# EcoTec, Inc.

Re: Notice of Intent, 12 Summer Street, Acton

Subject: 5th Review Letter: Revised Plans and Replication Specifications

**Sheet 5 plan section:**

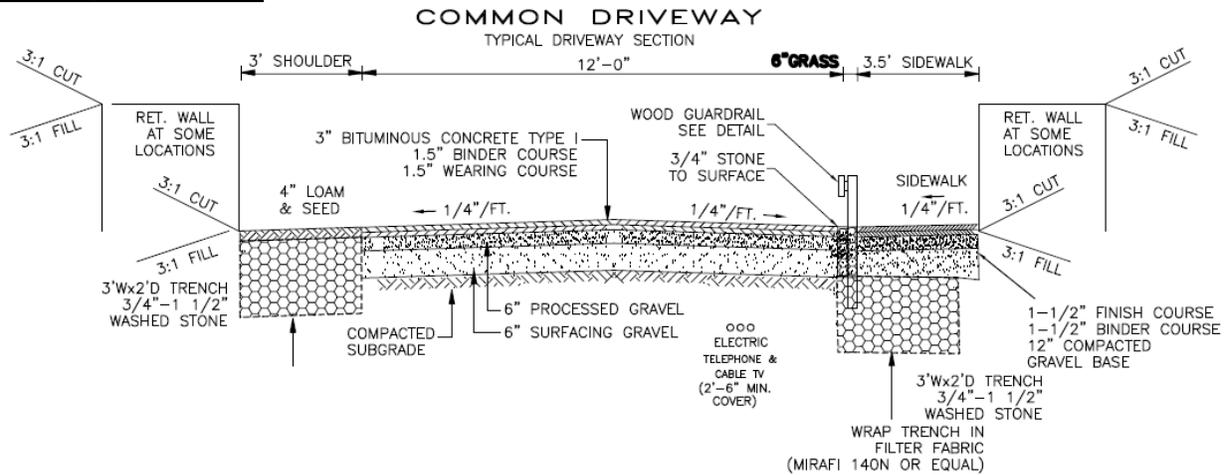
I have also repeatedly questioned the need for the paved asphalt sidewalk. The sidewalk remains on the proposed plans, and includes a 3 foot wide by 2 foot deep infiltration trench (similar to the infiltration trench on the opposite side of the proposed driveway). Water flow to the infiltration trench is via a 6 inch wide stone connecting channel to the ground surface between the sidewalk and the driveway. This narrow stone conduit would be fairly difficult to construct, requiring careful oversight. I also note that the Typical Driveway Section (see plan section pasted below) still also notes that the 6 inch strip between the sidewalk and the driveway is to be grass. If the

Commission votes to approve the project, I suggest a condition requiring plan revision to remove the notation that the 6 inch wide strip be planted with grass.
